Seabrook Station ASR Methodology LAR: Structural Deformation

LAR 16-03

Methodology and Responses to RAIs D2-D8

November 17, 2017

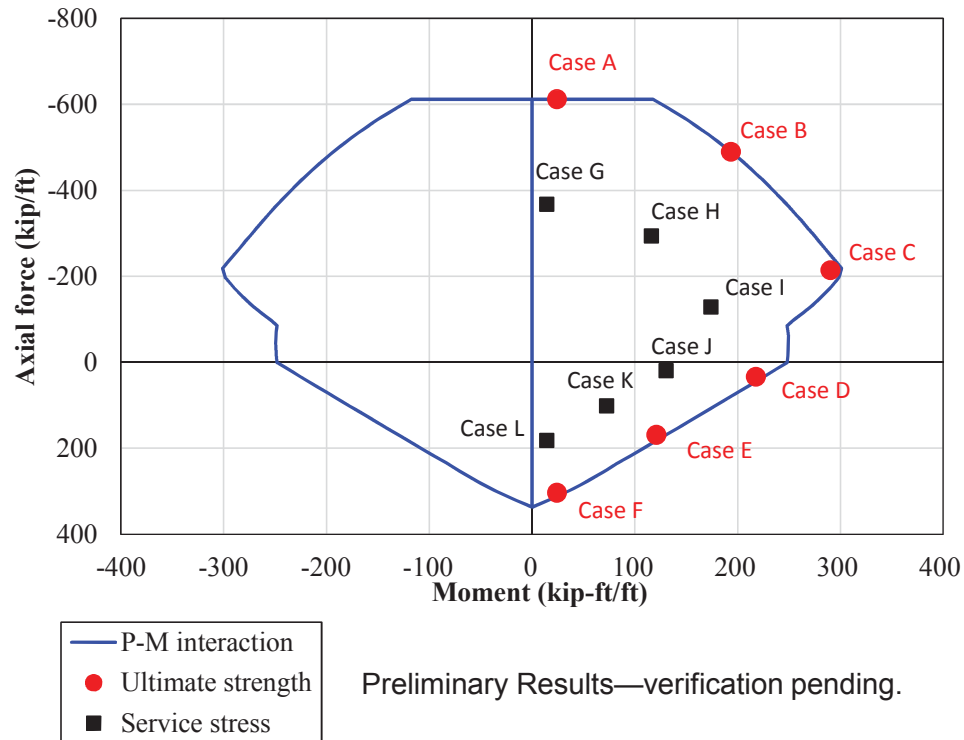
Request - Explain, with sufficient technical detail, how the proposed method of evaluation for ASR-affected structures verifies that the stresses and strains in the concrete and reinforcement remain within elastic limits based on realistic behavior under normal operating (service) load conditions, including ASR load.

- **Compliance with the ACI Code, as supplemented by the Methodology Document, ensures structures behave elastically, and the rebar and concrete stresses and strains remain within acceptable limits.**
